SUNDRY NOTICES AND REPORTS ON WELLS
Do not use this form for proposals to drill or to re-enter an abandoned well. Use form 3160-3 (APD) for such proposals.

8. Well Name and No.
NAGOOLTEE PEAK 5 FED COM 7

9. API Well No.
30-015-32603-00-S1

PROPOSED

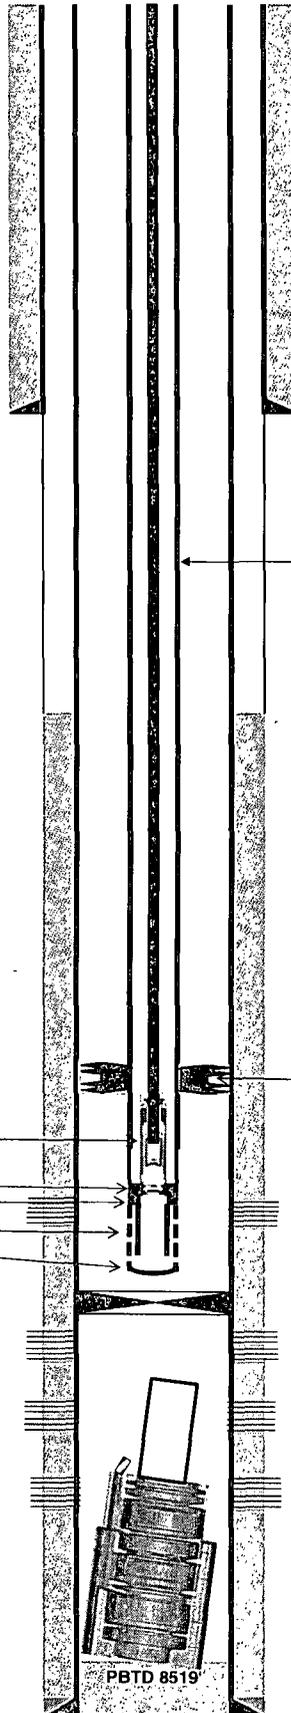
OXY USA WTP LP respectfully request permission to set a CIBP at 8189'. We plan on setting this plug when we enter the wellbore to re-stimulate the existing perms. We plan on doing this to abandon the perms that are blocked by a fish that is stuck in the hole and to help reduce the amount of water the well is producing.

8095' per operator

CIBP @ 8168' 8085'
